UNITED STATES ENVIRONMENTAL PROTECTION AGENCY

REGION 5

OCT 2 1985

This letter is intended to address certain issues that required further review following the August 22, 1985 discussion between David C. Bach, Donald E. Park, Harold F. Mason and yourself of Ethyl and Thomas W. Daggett and Nicholas J. Longo of the U.S. Environmental Protection Agency (U.S. EPA). This meeting was held following the completion of vertical and horizontal soil analysis for 2,3,7,8-TCDD at the Sauget, Illinois facility.

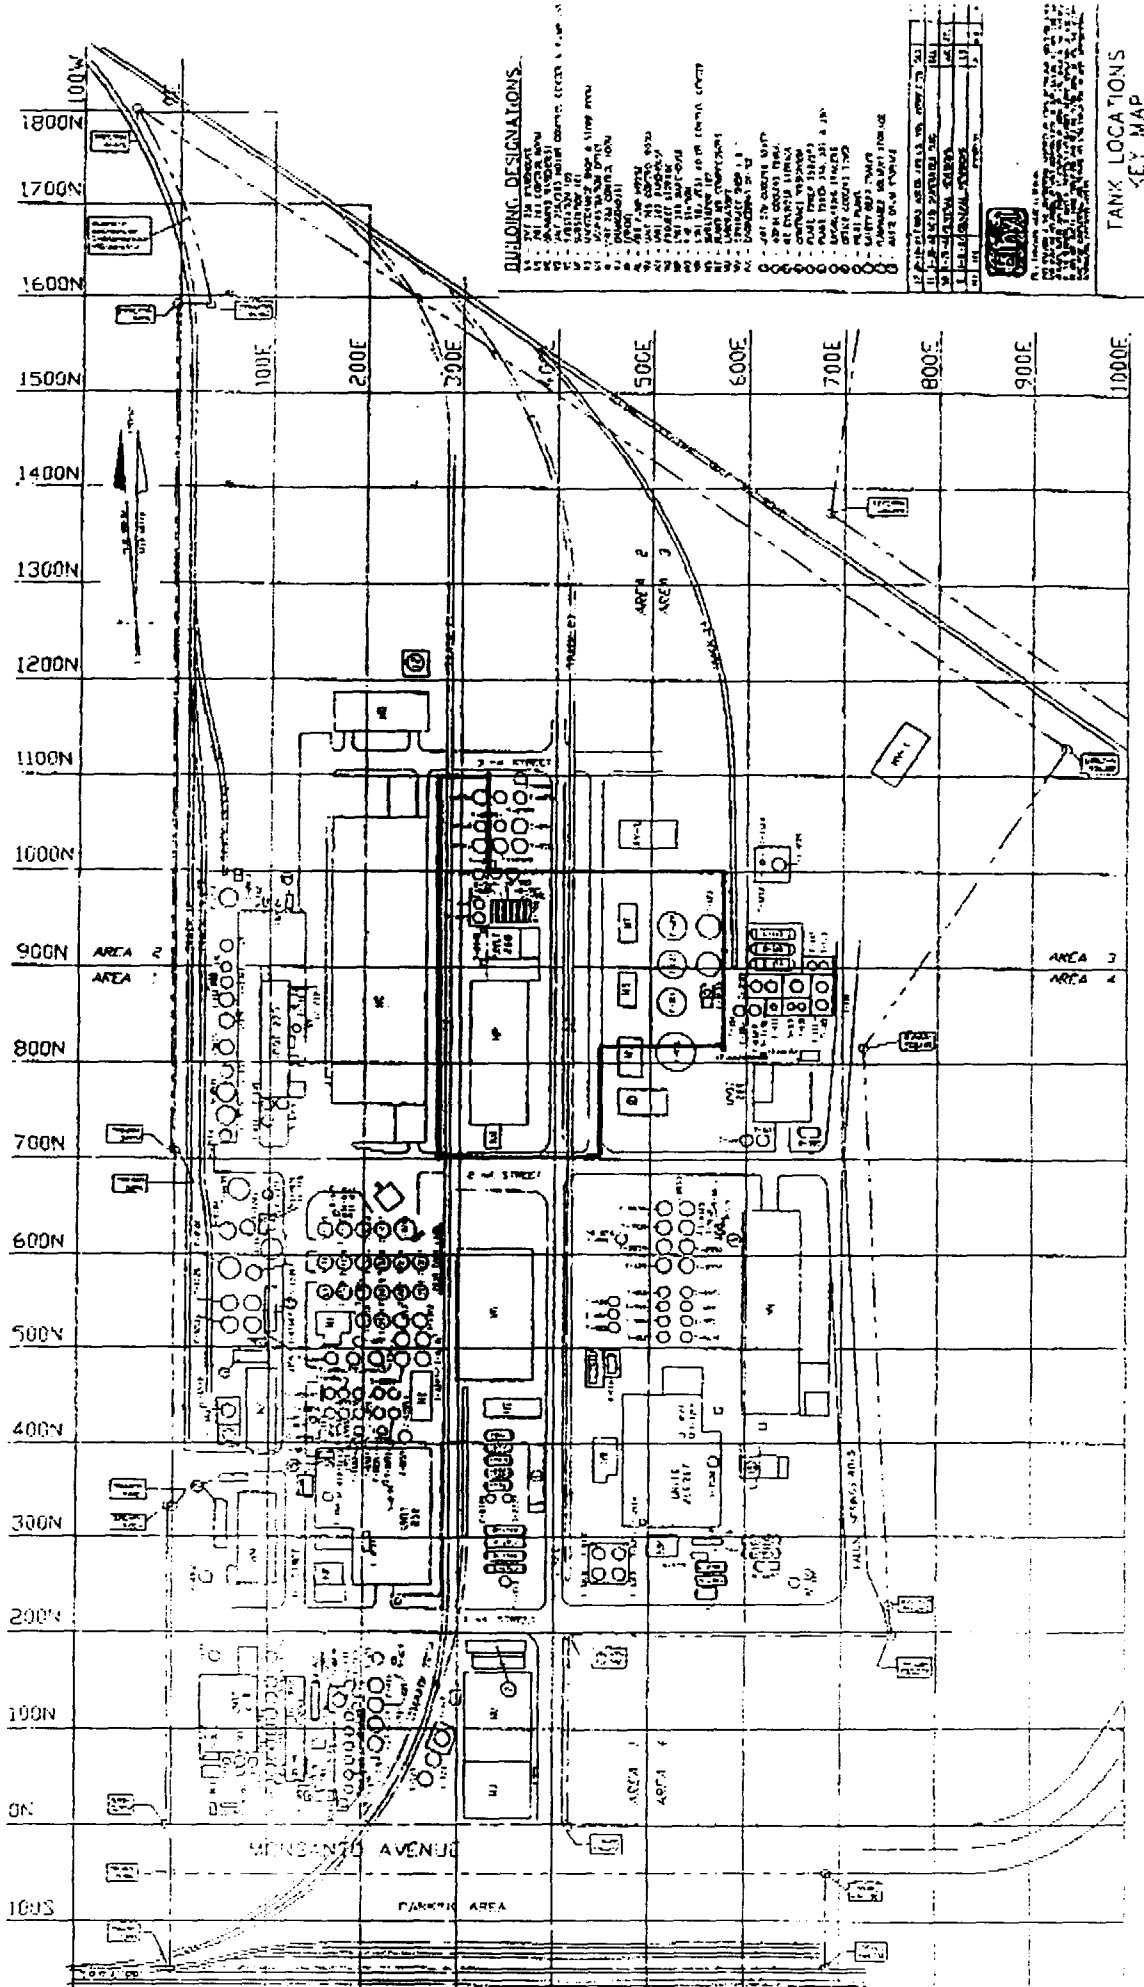
Ethyl proposed not to include in any construction restraint area that area contaminated at the 1-5 ppb 2,3,7,8-TCDD based on a July 9, 1984 Center for Disease Control document that indicated a reasonable level for a clean-up standard would be 5 ppb. It is our understanding that this assessment was intended to address general industrial activity, not construction activities that would be expected to disturb the soil. Despite the fact that this is an industrial facility, U.S. EPA is concerned with short term exposure to construction workers to soils over 1 ppb. U.S. EPA is therefore designating the following area as significantly contaminated:

From a point 285E, 700N north to point 285E, 1100N; east to point 330E, 1100N; south to point 330E, 1000N; east to point 585E, 1000N; south to point 585E, 820N; west to point 435E, 820N; south to point 430E, 700N; and west to point 285E, 700N.

The area bounded by 1400N, 1600N, 50E and 250E should be considered as contaminated. The soil from this area is not to leave the facility but other construction restraints are relieved.

In addition, Track 23 north of the significantly contaminated area to the northern boundary should be considered significantly contaminated within 10 feet of either side of the track. 2,3,7,8-TCDD samples should be taken along the track at the intersection with 1200N and 1400N. Two samples should also be taken off-site; one before the juncture with Track 24 and one after the juncture with Track 21.

With this letter, construction restraints on the facility are removed outside the significantly contaminated boundaries indicated except for a requirement that any soil excavated from areas where any level of 2,3,7,8-TCDD has been detected must be maintained on-site. This includes the NC expansion project. *
